Project: IEEE P802.15 Working Group for Wireless Personal Area Networks (WPANs)

Submission Title: Comment Resolution LB-95

Source: Henk de Ruijter, Ping Xiong, Silicon Labs
940 Stewart Dr, Sunnyvale, CA, USA

Purpose: Comment Resolution for comments collected from LB-95

Comment ID: 1174 – slide 2 of 3

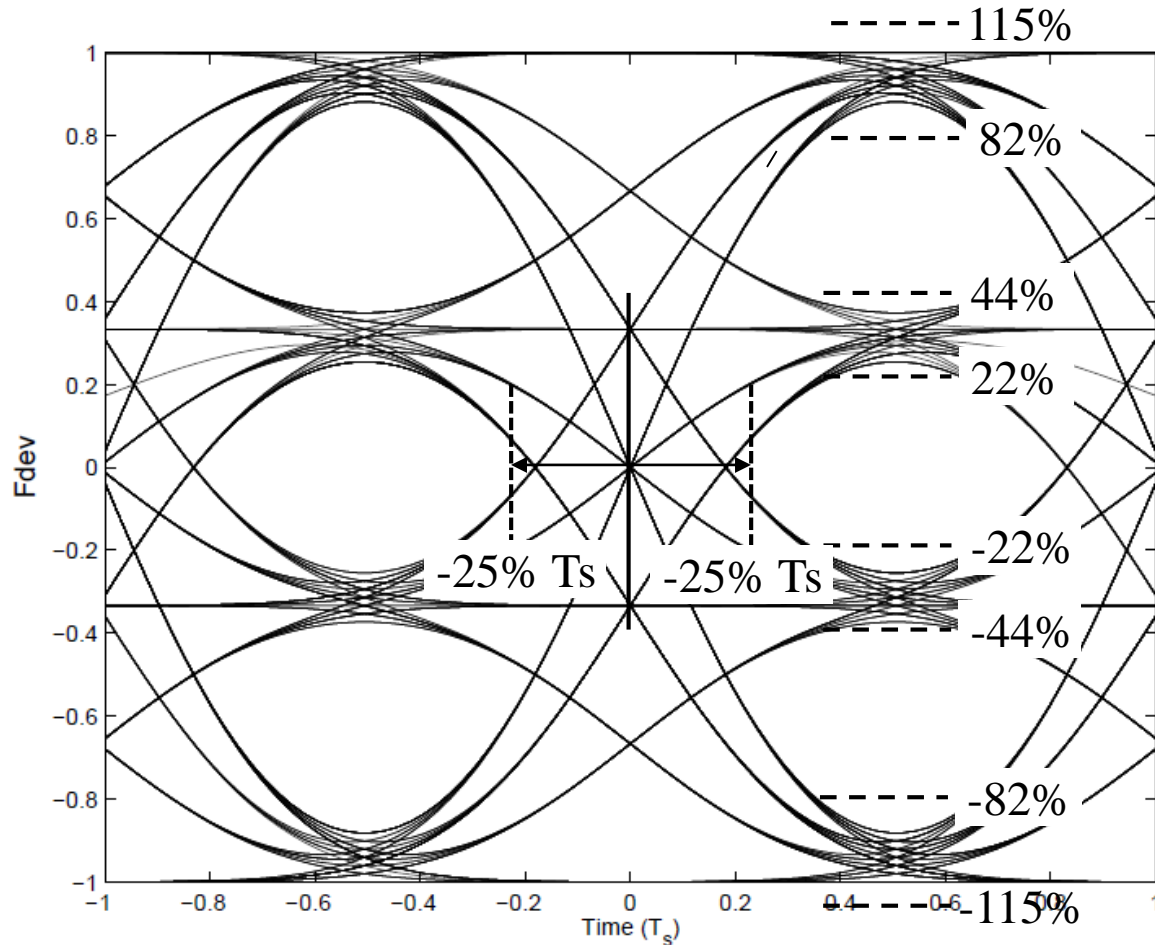
Comment: The frequency deviation tolerances are too coarse. Will degrade the receive sensitivity.

Proposed change: Reduce the deviation tolerance.

Resolution: Accepted in principle. Add new figure below to sub clause 31.2.5.

Replace sentence "The frequency deviation tolerance shall be as given in 18.1.2.3.1" by "The frequency deviation tolerance for 2-GFSK shall be as given in 18.1.2.3.1. The frequency deviation tolerance for 4-GFSK shall be as given in Figure xx"
